Amending Existing Wetlands Application

We are requesting re-approval of this project due to some additional walls that came down during demolition. Everything with the project remains the same and the walls that came down will be replaced in the same place but built to code. Existing walls would not have supported new build due to rot, being built with 2" x 4" not 2" x 6" and being placed at 18" not 16" stud spacing. Entire footprint will sat the same as approved. We may add a nursery on the second for, on the west side, out of the Wetlands area. This would not be a new footprint, just additional space on the second Fl.

WETLANDS PERMIT APPLICATION

13 Dickerson Drive; SCTM #700-18-3-35.2

1 FIRST FLOOR PLAN

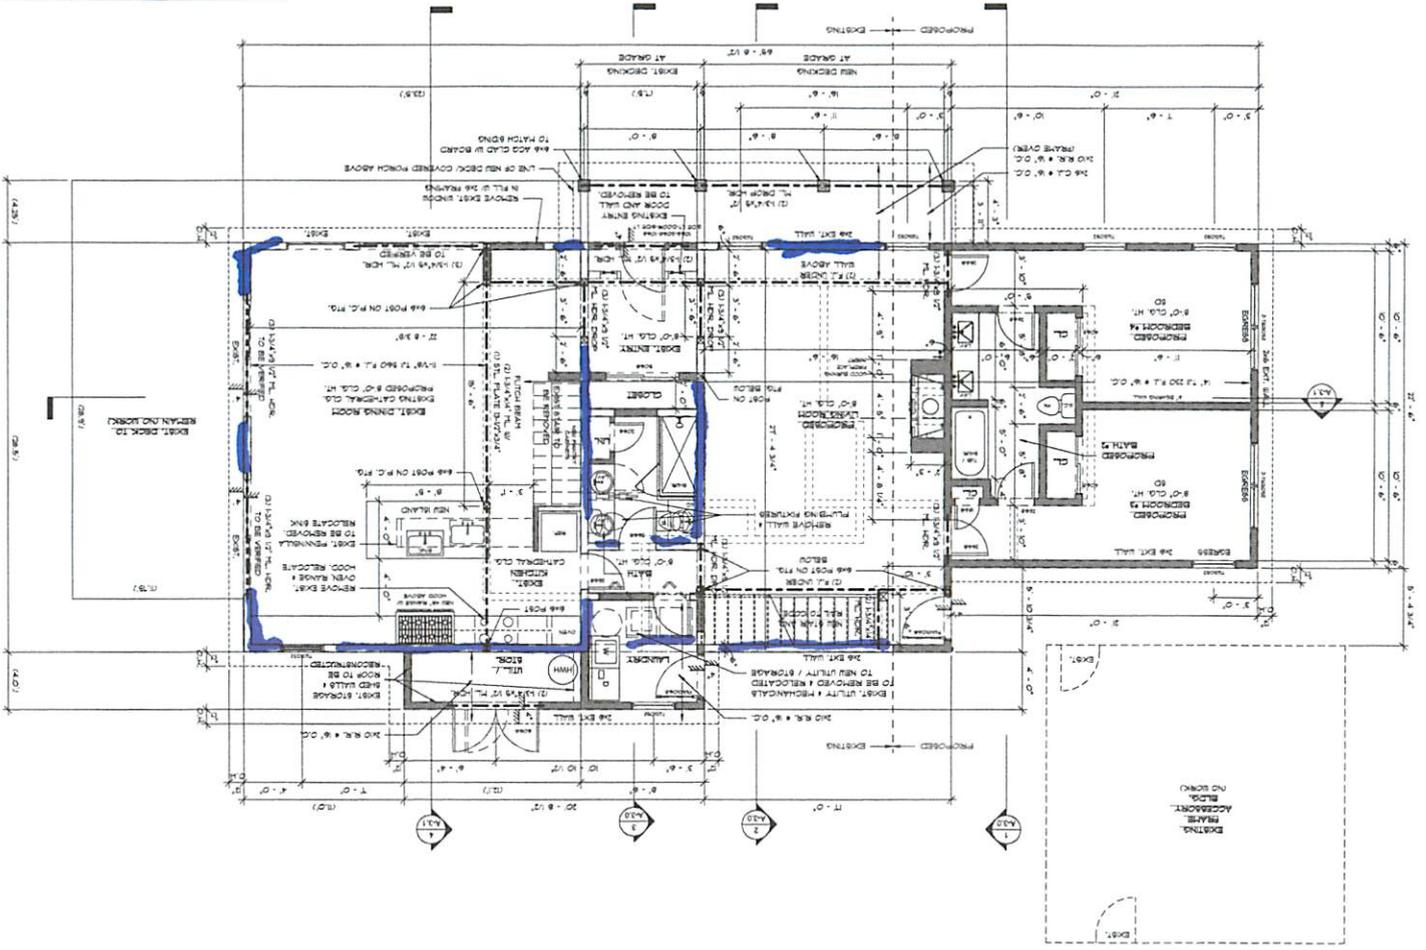
EXISTING WALLS came down will be Rebuilt in same place to code
